SUBDIVISION REVIEW SHEET

CASE NO.: C8-2020-0141

SUBDIVISION NAME: Velocity Preliminary Plan

CITY OF AUSTIN –DEVELOPMENT SERVICES DEPARTMENT SUBDIVISION APPLICATION – MASTER COMMENT REPORT

SPIRIT DRIVE
(73' R.O.W.)

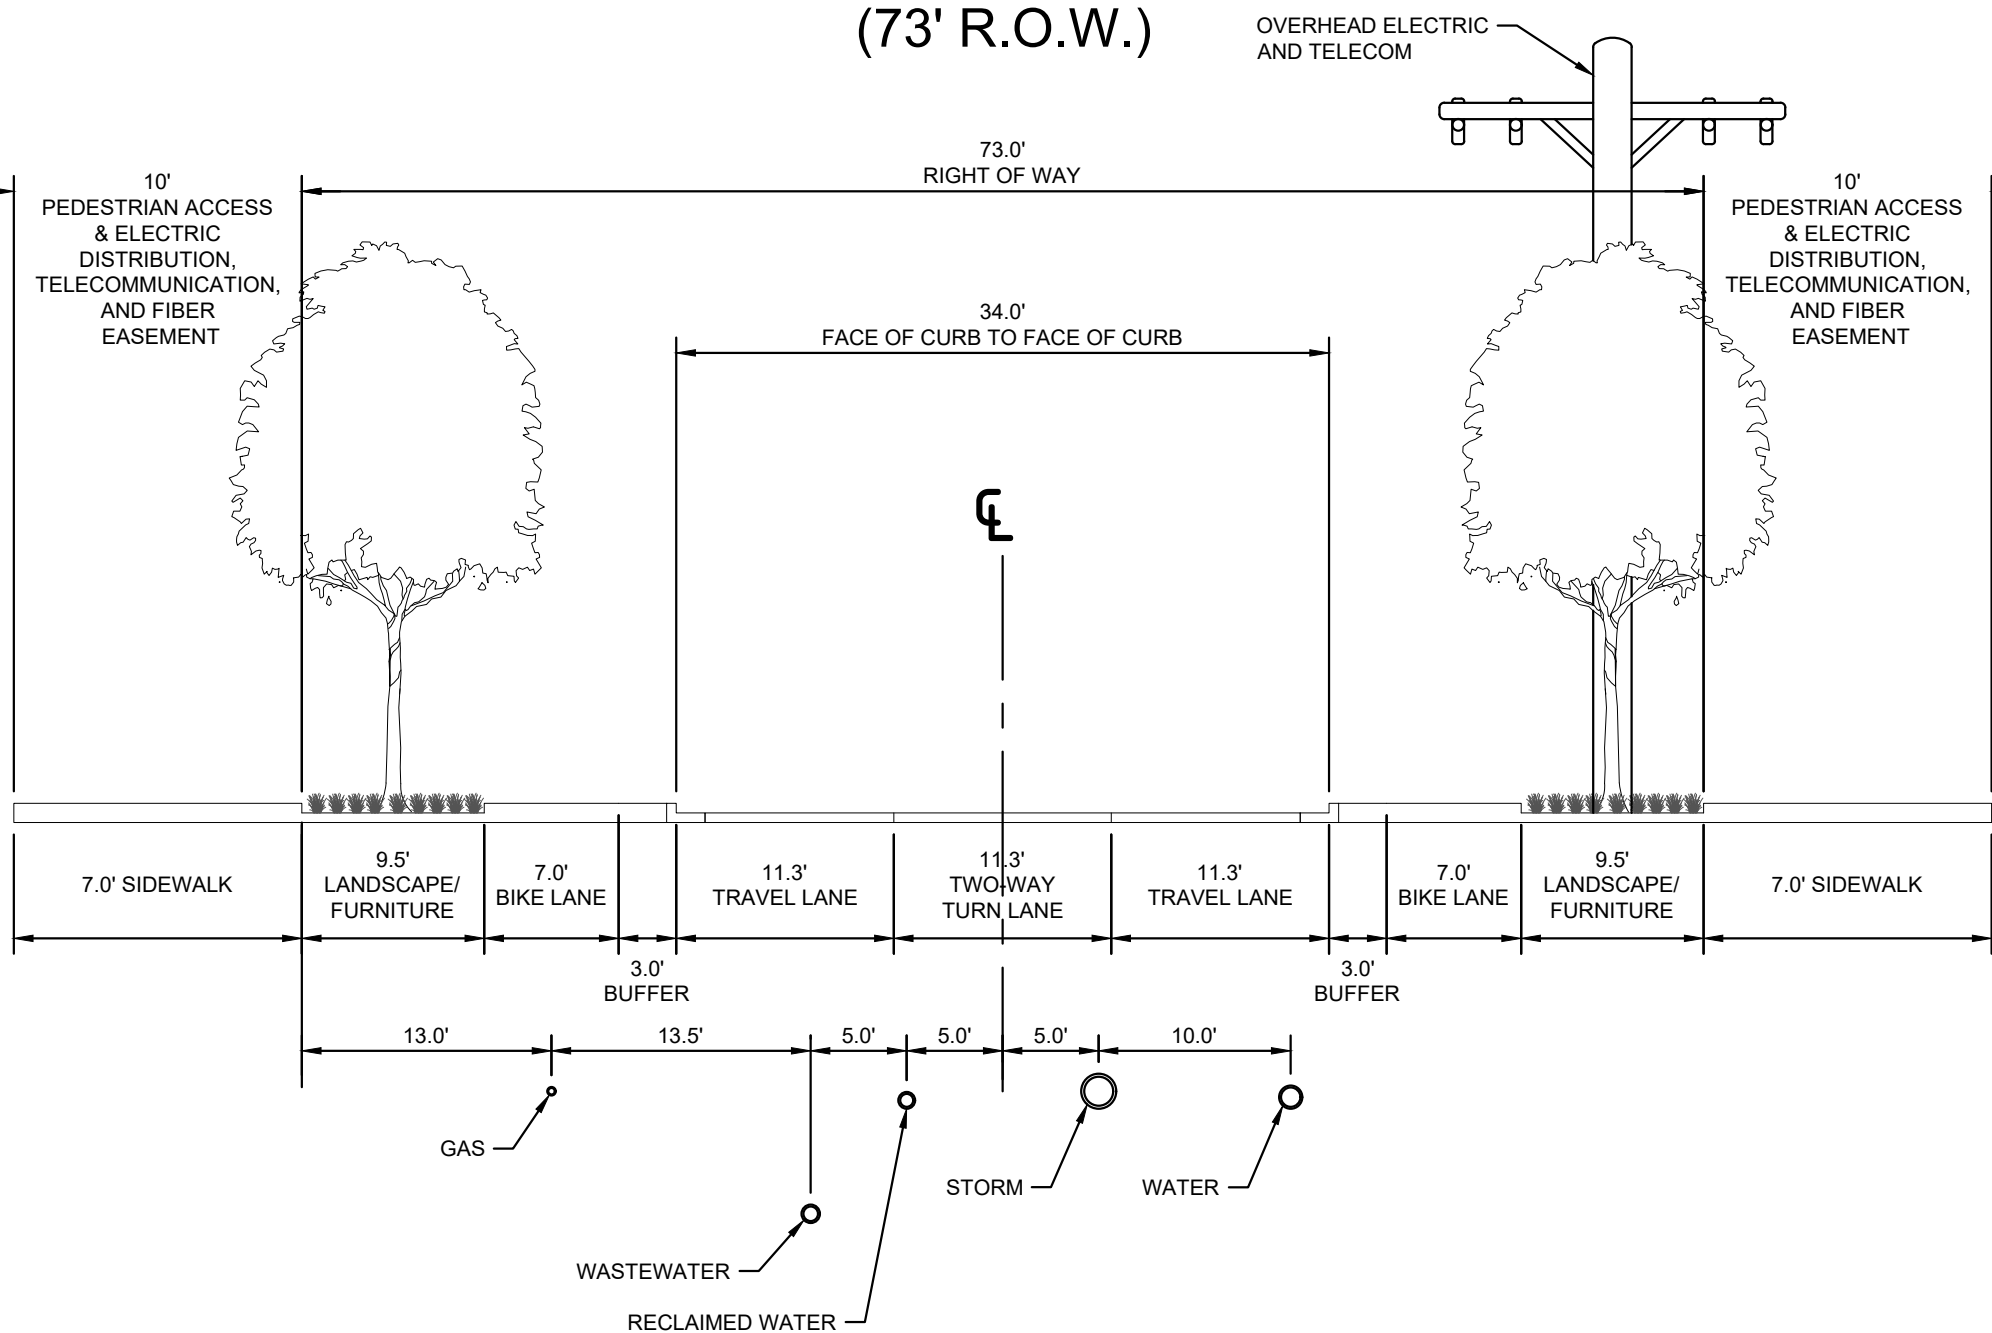
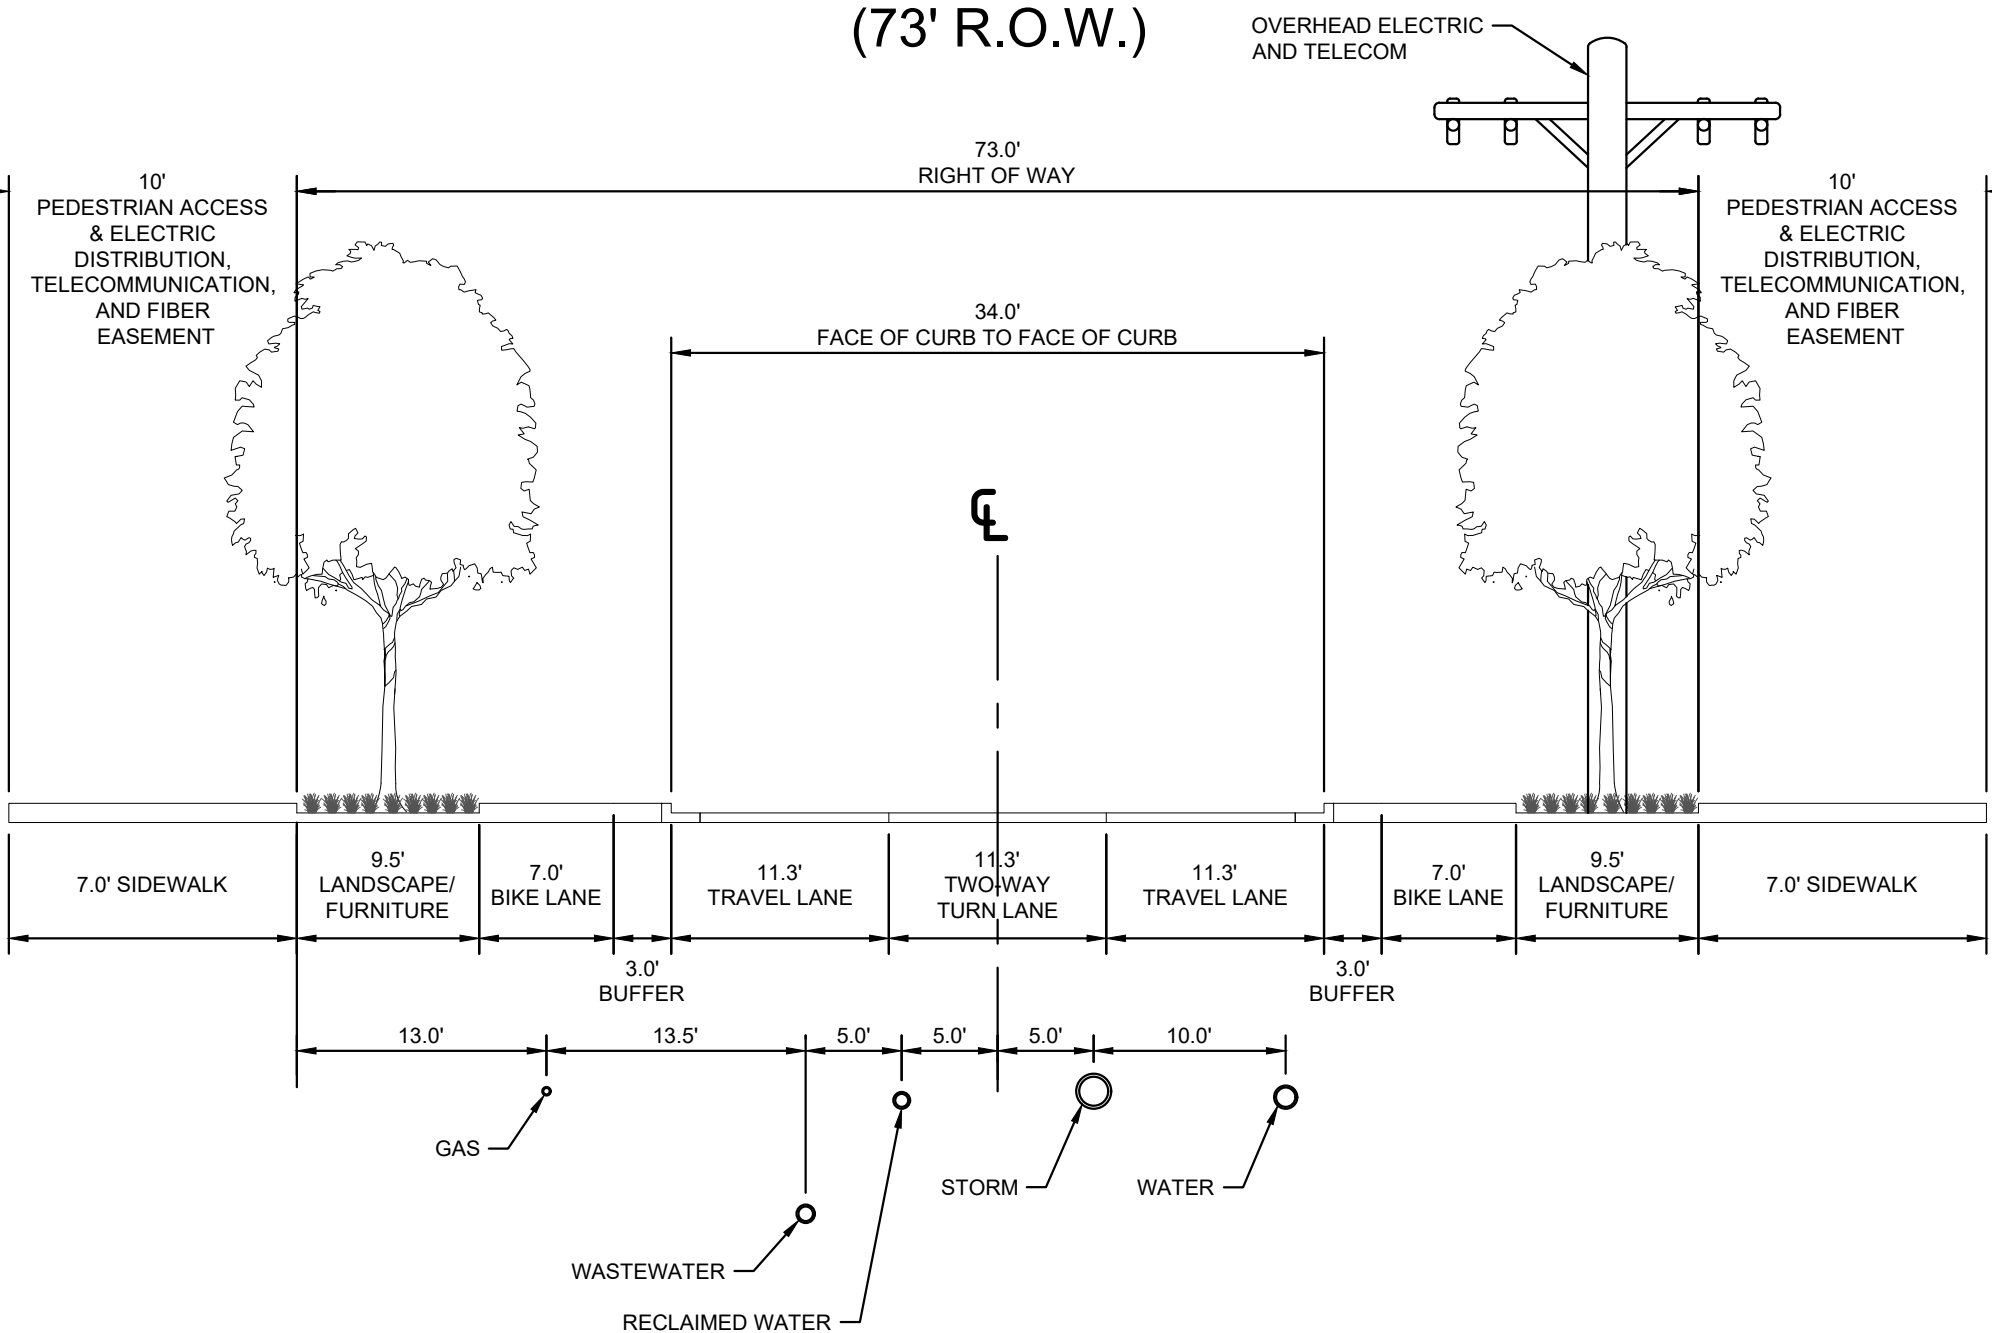
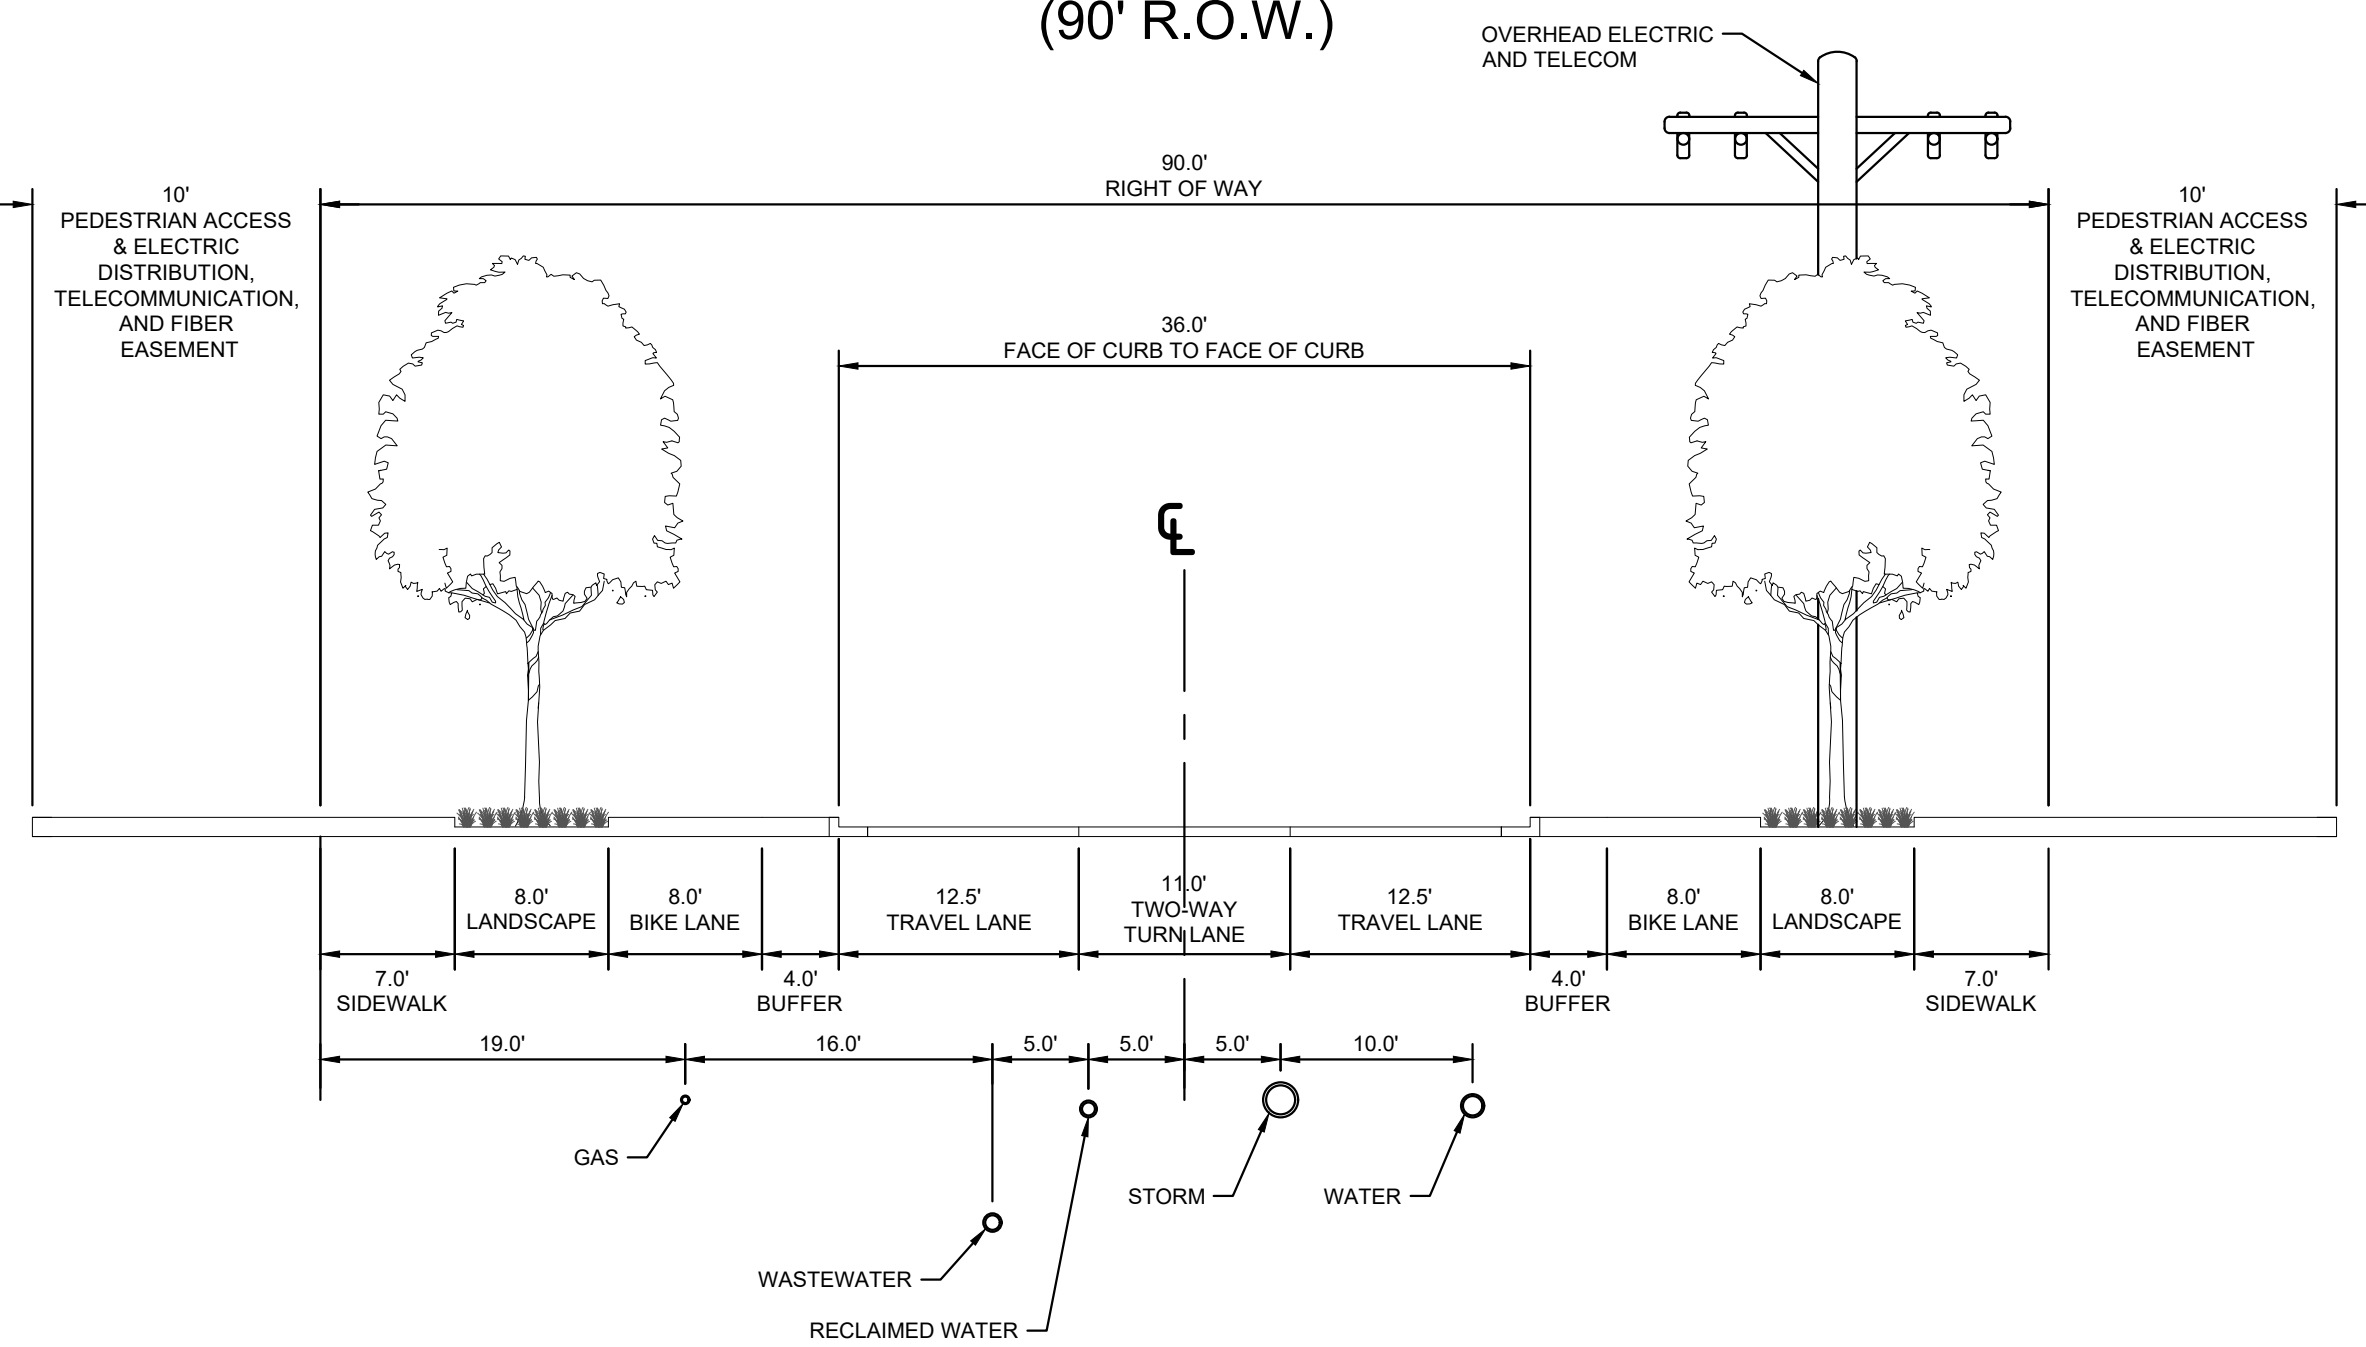
AD1. Not Cleared. SKY PARK COMMONS – Park is on the do not use list NOTE1: Use of the COMMONS street type should be utilized in a high-density area surrounded by grassy knolls or grassy areas as stated in street name reservation standards §25-4-155
